CALIFORNIA DIVISION OF MINES AND GEOLOGY
FAULT EVALUATION REPORT FER-244
SUPPLEMENT No. 1

SIMI-SANTA ROSA FAULT ZONE
Ventura County, California

by
Jerome A. Treiman
March 31, 1999

Figure 1 (FER-244, supplement no.1) - a portion of the Preliminary Review Map for the Newbury Park quadrangle (CDMG, 1998b) showing locations of studies and sites referred to in the text.

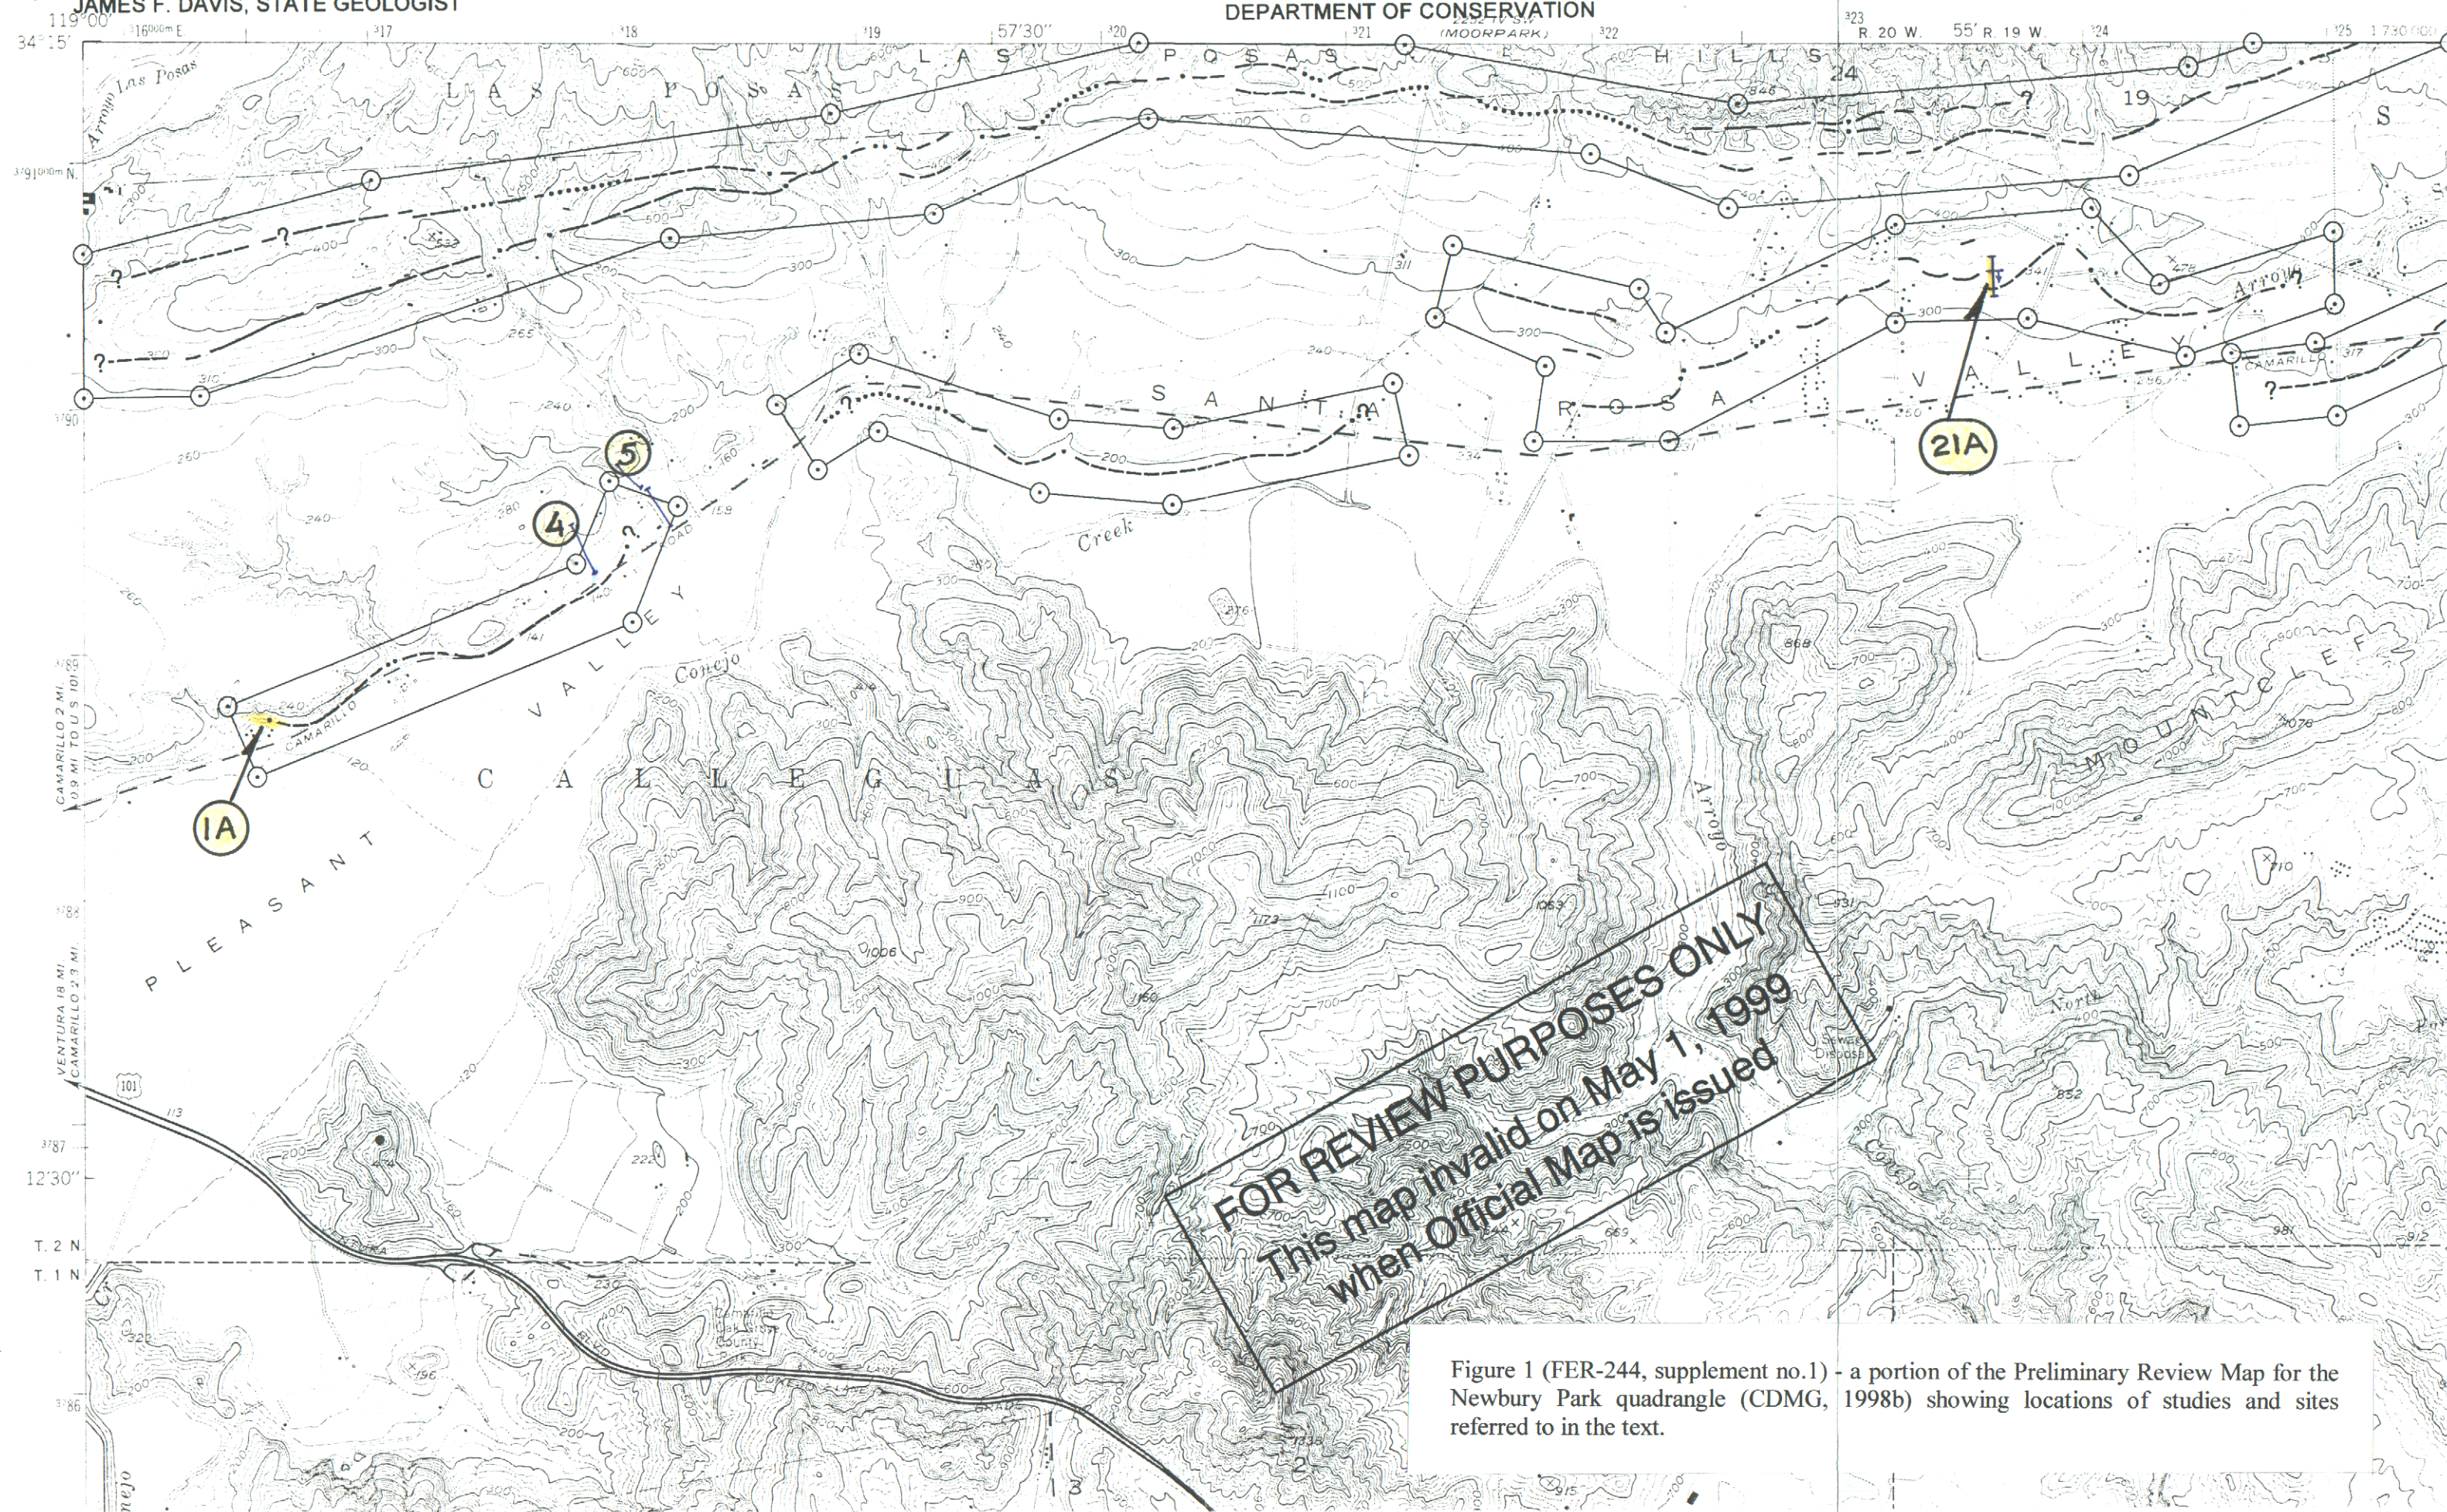
#1. Earth Systems Consultants (1999) submitted a request for reconsideration of the proposed zoning of the Santa Rosa Valley fault in the vicinity of localities 4 & 5 (Figure 1), asking that the EFZ (Newbury Park quadrangle – California Division of Mines and Geology, 1998b) be reduced in length so as to not impact the eastern parcels (vicinity of locality 5). They supported their request with the submittal of geotechnical studies for three adjacent projects, (Buena Engineers, 1988a; Earth Systems, 1997a & 1998a), including four reports not previously reviewed (Earth Systems, 1997c,d & 1998b,c).

#3) I was invited (in late December, 1998) to view trenching in progress at locality 1A (see Figure 1), being done by GeoSoils, Inc. Several trenches across the toe of an escarpment associated with the Santa Rosa Valley fault exposed moderate to high-angle reverse faults, including backthrusts. Adjacent beds of the Pleistocene Las Posas Formation were deformed severely and were overturned in some instances. Some of the faults appeared to displace colluvium or slope wash. Additional work in the alluvium south of the escarpment (utilizing CPT's) is reported to have located what may be the main buried thrust fault (Joe Cota, GeoSoils, personal communication, 1999).

#4) I was also invited (in November 1998) to observe a trench approximately 7km to the east, excavated by C.Y. Geotech, Inc. across a broad scarp or warp associated with the Santa Rosa Valley fault (locality 21A, Figure 1). Although this trench was only open a relatively short time and was incompletely cleaned at the time of my observation, a backthrust (dipping 43°S) was clearly exposed that offset and deformed late Quaternary alluvial deposits and may have affected soil thickness. The main thrust was not exposed, but Quaternary fan deposits were inclined 30°-40°S within the inferred upper plate. It is

No data was submitted that would affect the proposed zoning. The existing data, although showing lack of faulting in the young, upper alluvial materials within part of the proposed zone, did not demonstrate the absence of faulting at greater depths nor did the data refute the principal fault on which the zone is based.

No dating of deposits was done at either site #3 or site #4, but the findings are taken as corroboration of the presence of the Santa Rosa fault zone as a zone of latest Pleistocene to Holocene deformation and potential surface rupture.

Figure 2 (FER-244, supplement no.1) - a portion of the Preliminary Review Map for the Simi Valley West quadrangle (CDMG, 1998d) showing locations of studies and observations referred to in the text.

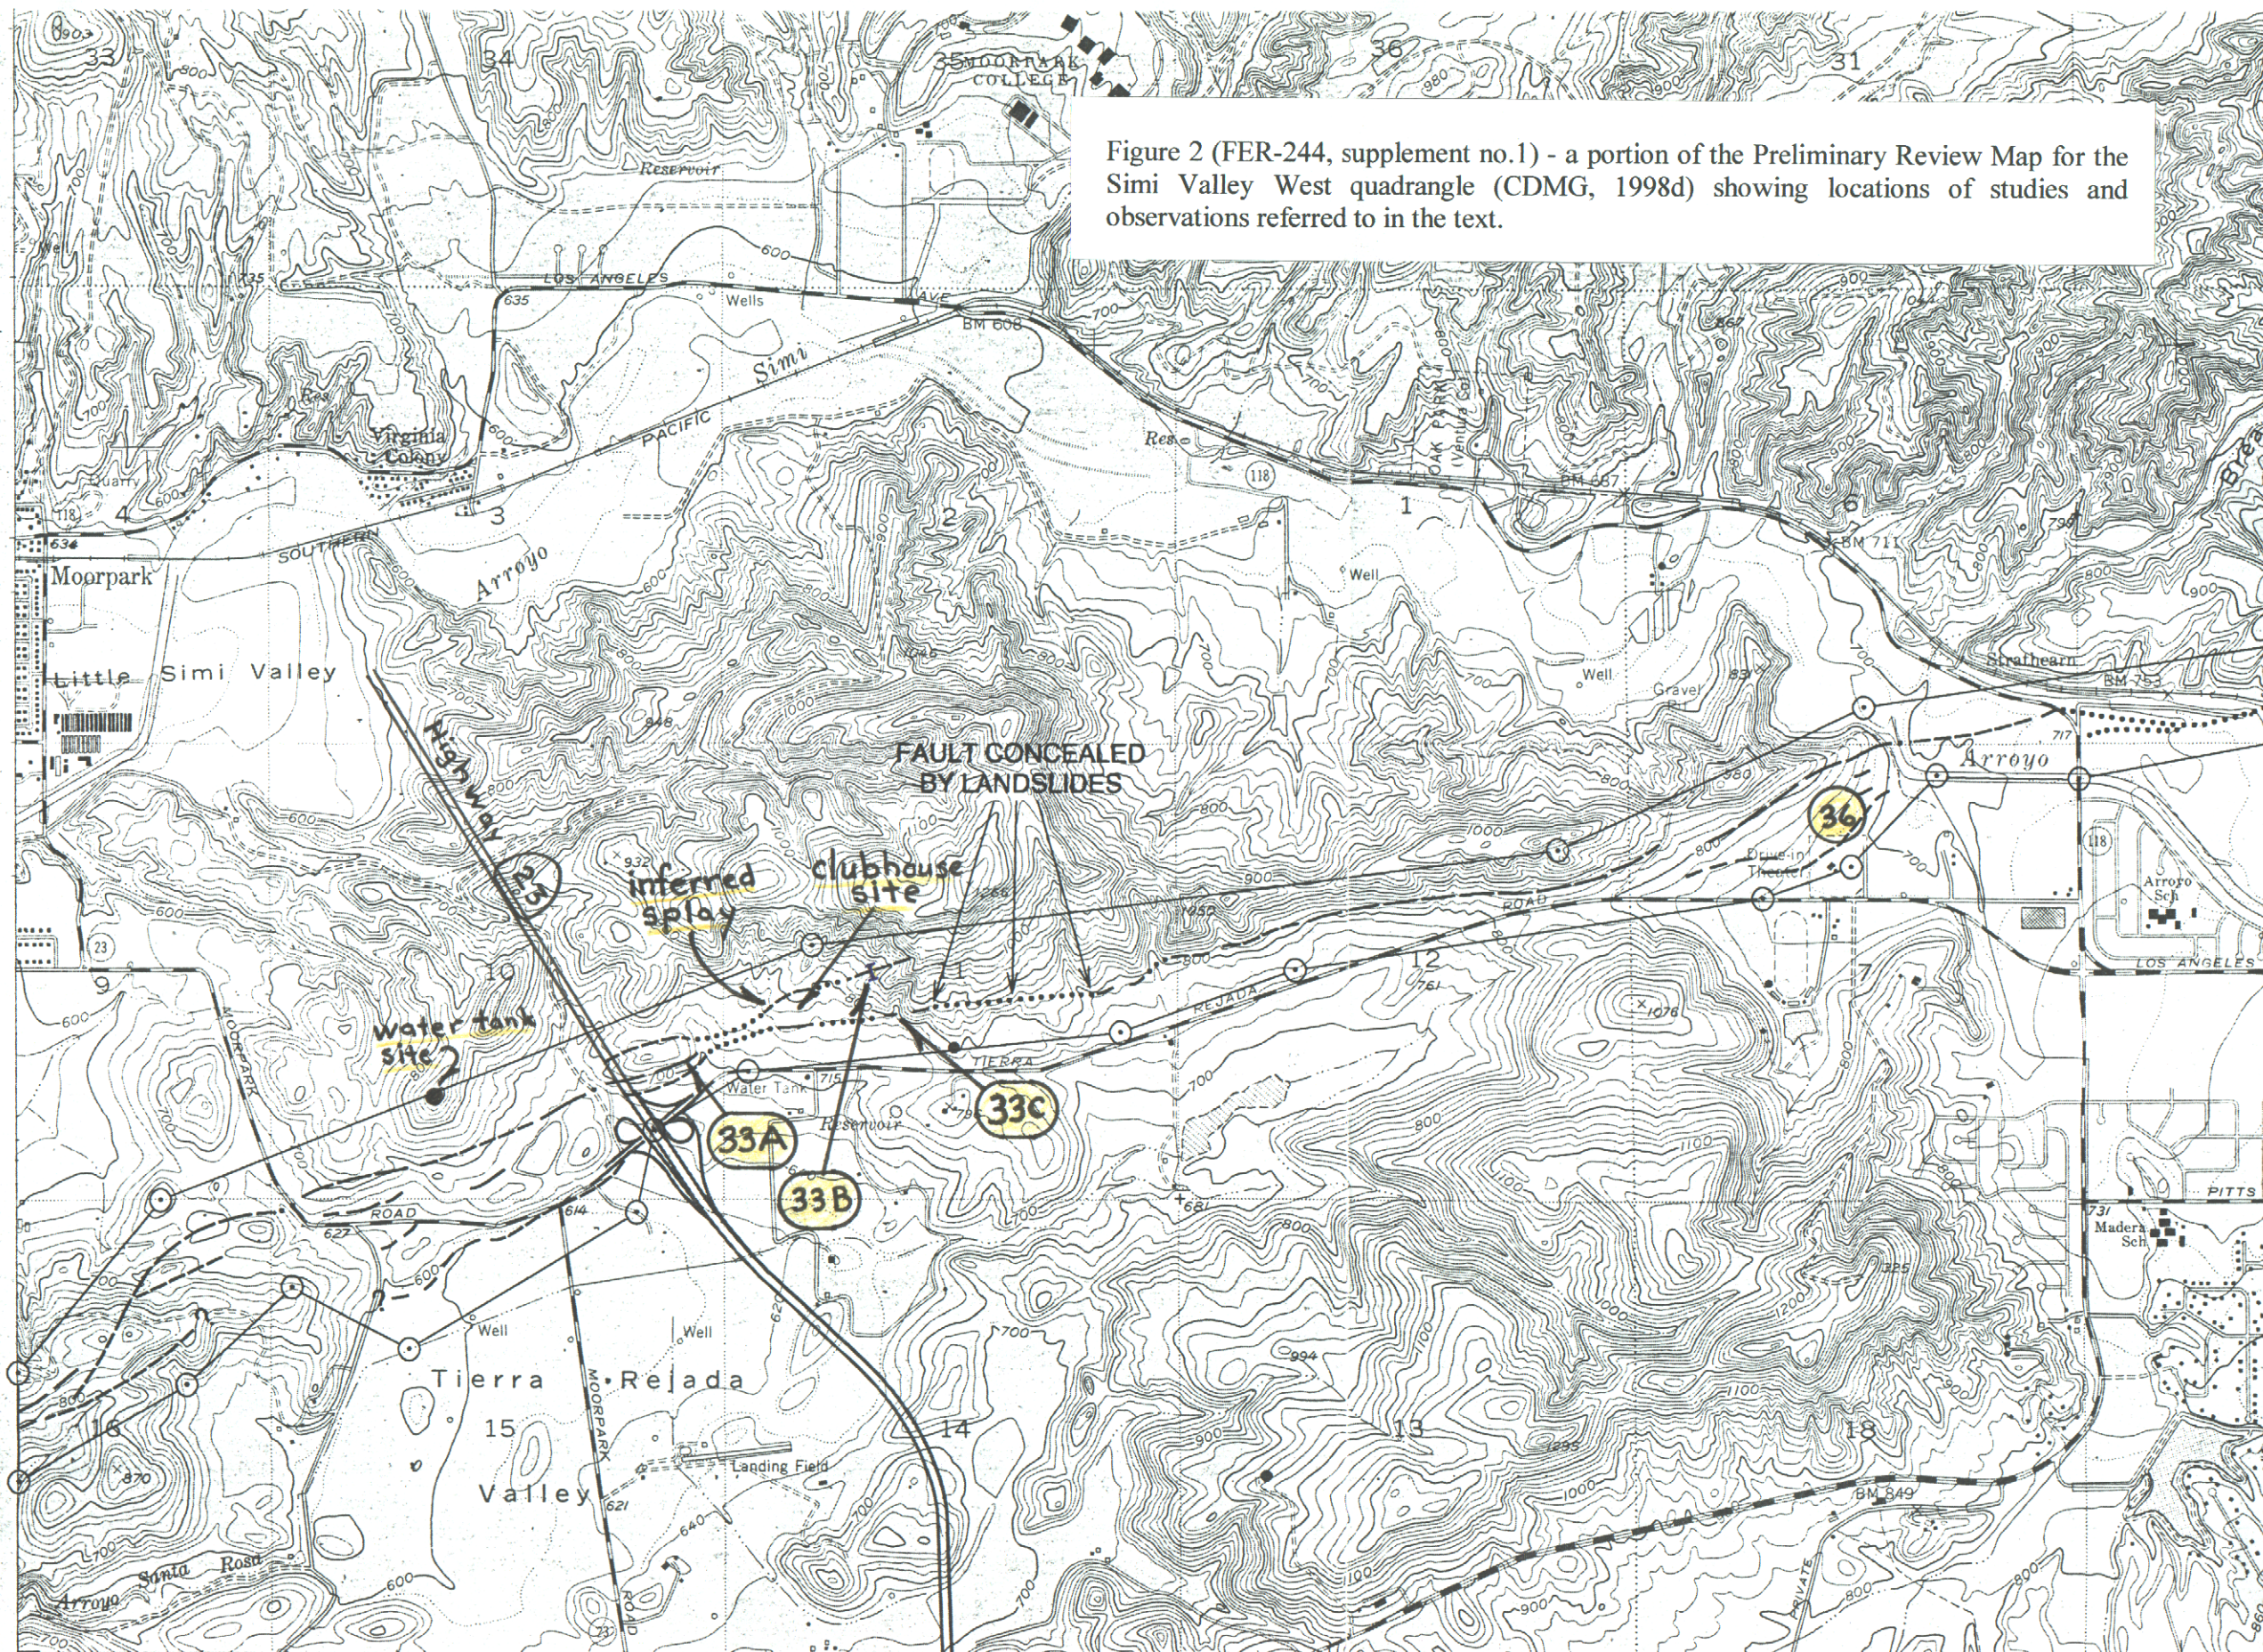
#2. Gorian and Associates submitted a letter and map (Gorian, 1999) addressing the zoning of the Simi fault north of Tierra Rejada Valley on the Simi Valley West quadrangle (California Division of Mines and Geology, 1998d). Observations made by the consultant during extensive grading for a golf course, east of Highway 23, did not find any evidence for the eastern portion of an inferred fault splay, north of the main trace, as shown on Figure 2. They also noted that in various studies west of Highway 23, in particular a water tank site, they had observed no faulting north of the Simi fault as shown on the preliminary review map. Based on these observations they have requested that the northern fault trace be deleted and that the EFZ be narrowed on the north. A small fault observed during subsequent grading of the clubhouse site was closer to the

main trace (~240') than the mapped splay, but no evidence was seen of the northern trace (Scott Simmons, Gorian & Associates, personal communication, 1999).

I was invited to the golf course site to observe investigations in early December 1998. The main fault trace of the Simi fault was exposed in a cut-slope (locality 33A, Figure 2) and in a canyon clean-out to the east (locality 33C, Figure 2). A trench was excavated across one of the stronger topographic features that was originally taken as an indication of the inferred fault strand (locality 33B, Figure 2). I inspected the trench, along with Scott Simmons of Gorian and Associates, and although two bedrock shears were observed within the Oligocene Sespe Formation south of the topographic break, these shears did not correspond to the suspect topographic feature. The topographic irregularity may have been due to resistant bedding or increased erodeability of an inset Quaternary channel deposit. No evidence was observed to warrant retention of the eastern part of the inferred fault splay through and east of the clubhouse site.

A bedrock fault was observed in grading being done to the north of the main strand (north of locality 33A), at the western side of the project. The age of this latter fault was not determinable due to stripping of the younger soils, but its location and orientation warrant keeping the eastern portion of the splay fault within the EFZ.
